**STAFF REPORT**  
**COMMUNITY DEVELOPMENT DEPARTMENT**

SUBJECT: SHP-2022-0010  
Idak Subdivision

Short Plat request to subdivide an existing single-family building lot into two (2) single-family building lots on approximately 2.09 acres in the R-2 zoning district, by Sawtooth Land Surveying.

### A. Short Plat (dated: August 2022)

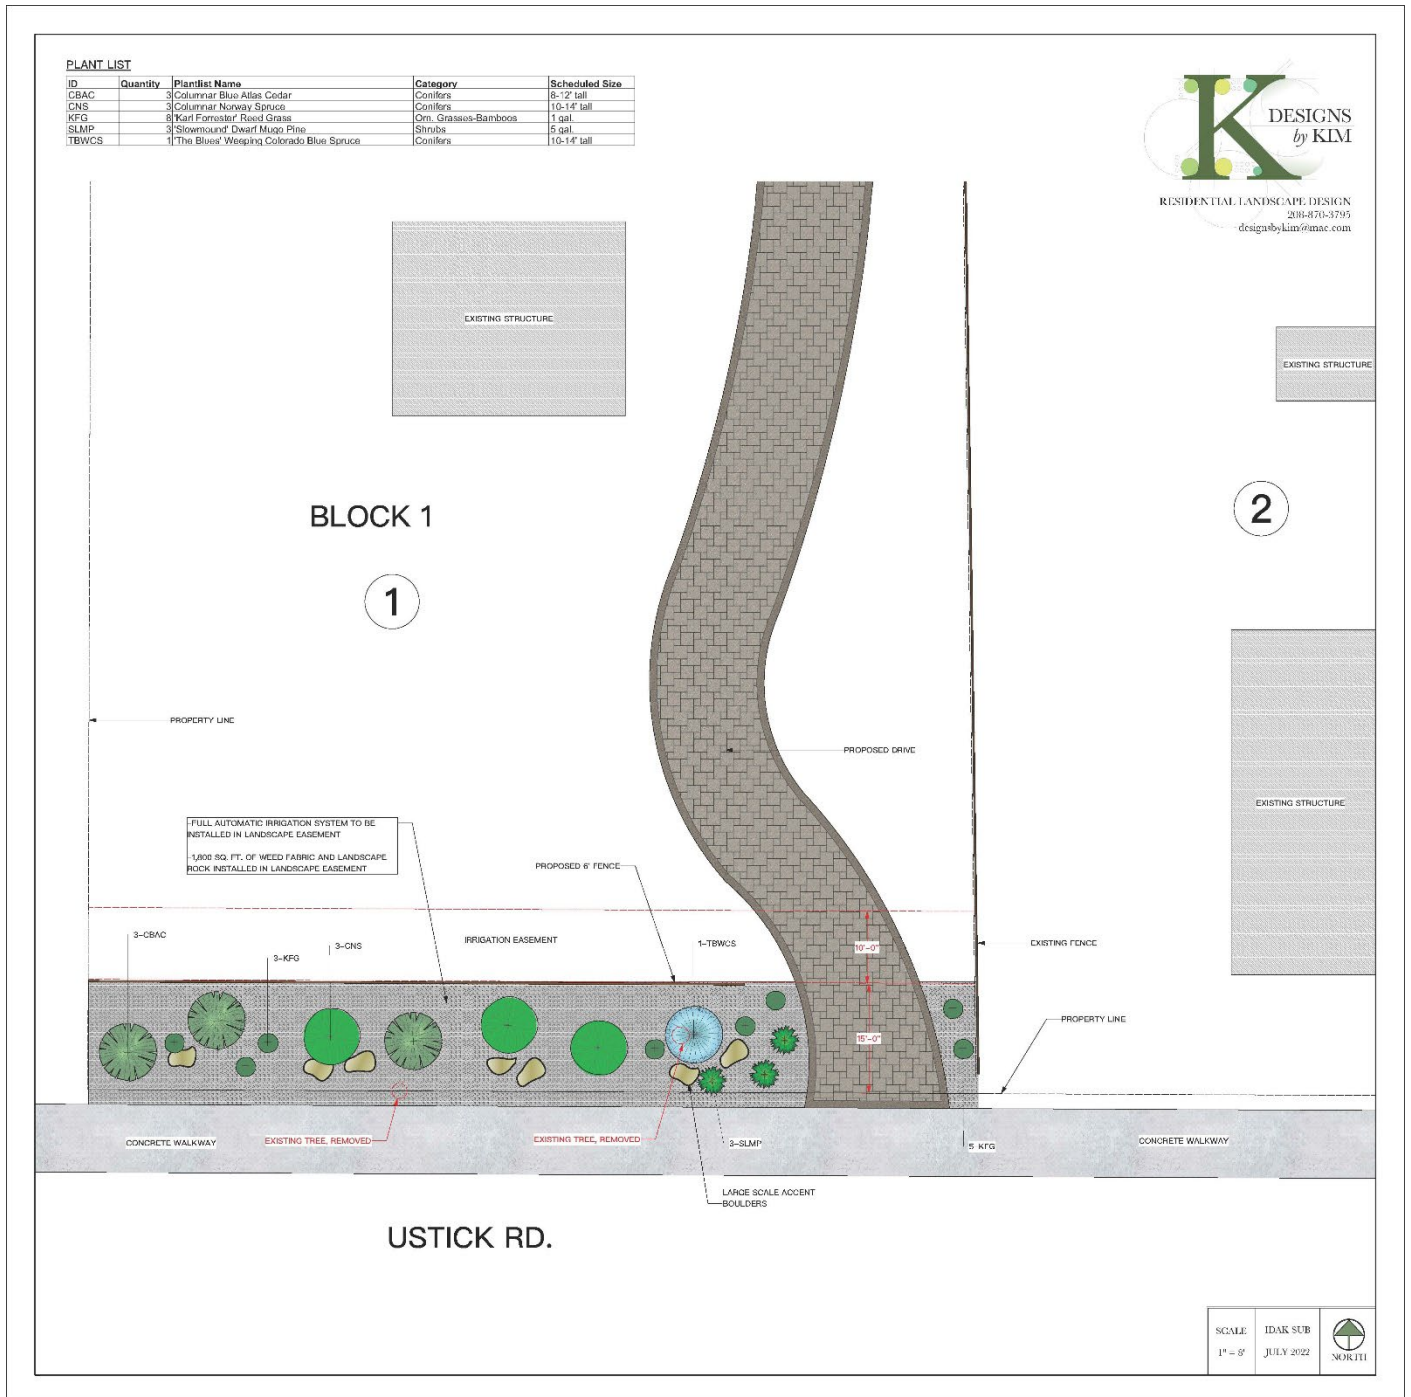
Current access to the property is through a shared driveway along the southeast corner of the property that is located on the adjoining county parcel to the east, 870 E. Ustick. However, according to the submitted plat, the access easement is on the subject property with a portion of the easement encroaching on the corner of the existing home and not on the adjacent county parcel. With the subject applications, the Applicant is proposing a new access for the new building lot located where the current curb cut exists to Ustick near the midpoint of the south property line.

UDC 11-3A-3 requires properties that currently take direct access to arterial streets to take access from a local street upon development. In this case, no existing local streets are available to take access from and Staff finds requiring this property owner to create a new local street would create minimal opportunities for future extension nor provide access to a relevant number of properties. Further, the intent of UDC 11-3A-3 is to “improve safety by combining and/or limiting access points to collector and arterial streets and ensuring that motorists can safely enter all streets.” Therefore, Staff is recommending the following revisions to the proposed access consistent with UDC standards:

1. Relinquish existing rights to the shared access easement with 870 E. Ustick;
2. Add a common drive, within a common lot, along the west and north property boundaries of the proposed Lot 2, the lot containing the existing home;
3. Show existing home and proposed home to take access from new common drive instead of the shared access to the east; and,
4. Add a note to the plat stating cross-access for the proposed building lots (Lots 1 & 2) and for access to 870 E. Ustick, consistent with UDC 11-3A-3.

In addition, it is unclear if the existing home has a garage consistent with off-street parking requirements in UDC 11-3A-6. The Applicant should verify the number of bedrooms of the existing

home and note on the plat the location of the garage. If there is no garage, the Applicant is required to construct a garage consistent with UDC standards.

4. The short plat prepared by Sawtooth Land Surveying in August, 2022 by Fritz Brownell, included in Section VI.A, shall be revised as follows:
  - a. Add a common drive, within a common lot, along the west and north property boundaries of the proposed Lot 2, the lot containing the existing home, substantially consistent with the exhibit in VI.C above.

- b. Show existing home and proposed home to take access from new common drive.
  - c. Add a plat note granting cross-access for the proposed building lots (Lots 1 & 2) of this subdivision and 870 E. Ustick to utilize the new common drive.

- d. Direct lot access to Ustick Rd is prohibited in accord with UDC 11-3A-3.
5. Per UDC 11-5B-5B.2, the Director (at the applicant's request) approved alternative compliance regarding the landscape buffer width on Lot 2 (UDC 11-2A-4). See "Alternative Compliance" section above for staff analysis.

10. Prior to obtaining City Engineer's signature on the plat, the Applicant shall provide written verification that their interest in the shared access easement (Inst. #310704) between 870 & 840 E. Ustick has been relinquished (i.e. a new recorded document releasing all interest in said easement).

## B. Landscape Plans (dated August 2022):

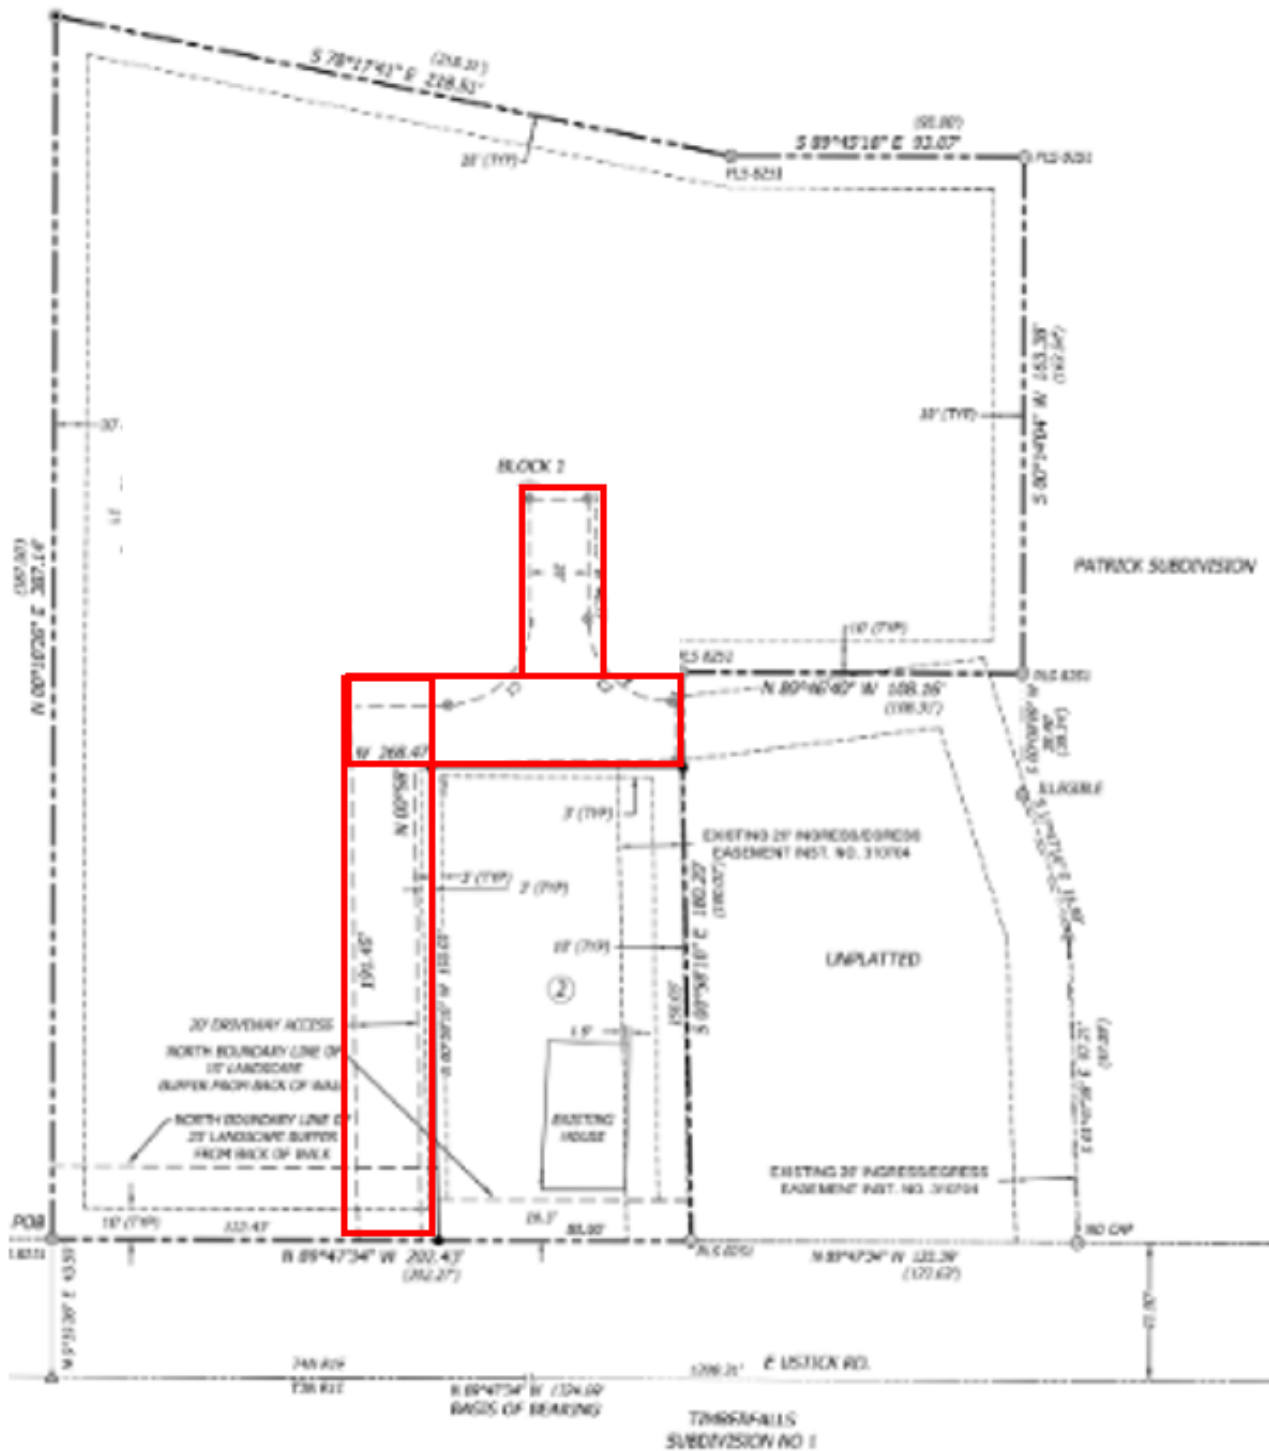
The Applicant has submitted two landscape plans that together depict the proposed landscape buffer along Ustick Road. Per UDC 11-2A-4, a minimum 25-foot wide landscape street buffer is required along Ustick. As discussed above, the Applicant is requesting Alternative Compliance to this requirement for the landscape buffer along Lot 2 for the existing home to comply with UDC dimensional standards. The submitted short plat depicts the required 25-foot landscape buffer on the remaining buffer length but the submitted landscape plan depicts only 15 feet of landscaping along Ustick on Lot 1. Staff does not support a reduction of the landscape buffer along Lot 1 and this area was not included in the ALT request, so the Applicant should revise the landscape plan prior to submitting for plat signature to depict the required 25-foot street buffer width. Further, the submitted landscape plan for Lot 1 does not appear to depict adequate ground cover consistent with UDC 11-3B-7 and UDC 11-3B-5 by depicting landscape rock as the main ground cover material. Therefore, the Applicant should revise the landscape plan to depict adequate ground cover to comply with UDC standards prior to City Engineer's signature on the plat.

According to the submitted landscape plans and plat, the Applicant is depicting a 15-foot wide landscape buffer along Ustick to be contained within an easement, as allowed by UDC 11-3B-7. This buffer is shown to depict two trees, a number of columnar trees, and shrubs. Further, placing the landscape buffer within an easement allows the building setback to be measured from the back of sidewalk instead of the back of the buffer; therefore, the landscape buffer will not create a setback nonconformity for the existing home since it is approximately 17 feet from the back of sidewalk.

6. Prior to submittal for the City Engineer's signature on the plat, revise the landscape plans to depict the required 25-foot wide buffer along Ustick Road on Lot 1 per UDC Table 11-2A-4 and vegetated in accord with UDC 11-3B-5 & 11-3B-7 standards.
